Contract #: 04-0120F4Cty: SF/ALA Rte: 80 PM: 13.2/13.9File #: 69.25B**QUALITY ASSURANCE -- NON-CONFORMANCE REPORT****Location:** Changxing Island, Shanghai, P.R. China**Report No:** NCR-000739**Prime Contractor:** American Bridge/Fluor Enterprises, a JV**Date:** 23-May-2010**Submitting Contractor:** Zhenhua Port Machinery Company, Ltd (ZPMC), Changxing Island**NCR #:** ZPMC-0702**Type of problem:****Welding****Concrete****Other****Welding****Curing****Procedural****Bridge No:** 34-0006**Joint fit-up****Coating****Other****Component:** Angle Plates on Shear Plate**Procedural****Procedural****Description:****Reference Description:** There are Two Angle Plates Damaged and Distorted on the Shear Plate WD1- A25**Description of Non-Conformance:**

NON-CONFORMANCE REPORT TRANSMITTAL

Job Name: SAS Superstructure
Document No: 05.03.06-000699

Reference Description: Angle Plates Damaged and Distorted / Tower / Shear Plate WD1- A25

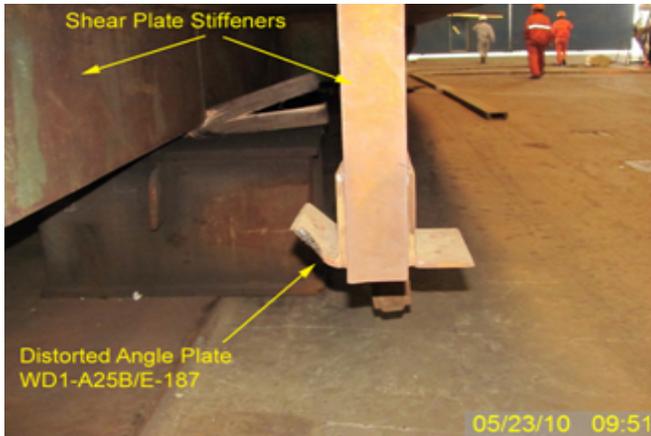
During random visual inspection in Bay 11, Quality Assurance Inspector discovered the following issue:

- Two (2) angle plates in the top elevation of Shear Plate were damaged and distorted.
- The welds are identified as WD1-A25B/E-174,187; fillet weld.
- Tower Lift 1 Shear Plate WD1-A25.
- The member is located in Bay#11.
- These angle plates were previously VT and MT tested.
- The Notice of Witness Inspection Number (NWIT) is 005762.

“In handling and shipping of the steel work, every care shall be taken to avoid bending, scraping or overstressing the pieces. All pieces bent or otherwise injured will be rejected.”

Finished members shall be true to line and free from twists, bends and open joints.

Proposal Pending from Contractor.
